Office Action Summary	Application No.	Applicant(s)	
	10/528,052	ARAI ET AL.	
	Examiner	Art Unit	
	Jami M. Valentine, Ph.D.	2815

DETAILED ACTION

FIG. 1

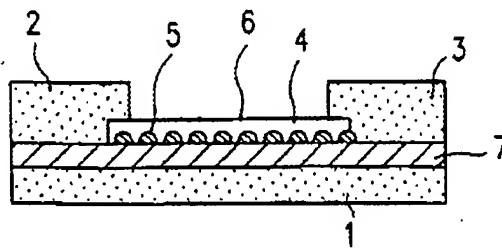
12. Per **Claim 1** Kado (e.g. figure 1) discloses a resistance-changing function body, comprising

- an object made of a first substance (4) and interposed between a first electrode (2) and a second electrode (3); and
- a plurality of particles (5) made of a second substance and arranged within the object so that an electrical resistance between the first electrode and the second

electrode is changed before and after application of a specified voltage to between the first electrode and the second electrode, wherein the first substance makes an electrical barrier against the second substance. (see column 6 lines 40-51)

14. Per **Claim 8** Kado (e.g. figure 1) discloses the fabrication of at least two memory resistance-changing function bodies as defined of claim 1, arranged in a direction parallel to a substrate (column 6 lines 27-36 discloses the patterning of multiple devices during one sputtering process.) as well as where the objects made of the first substance of memory cells mutually adjacent in the direction parallel to the substrate are integrally continuously formed (e.g. figure 1, see also column 6 lines 19-25)
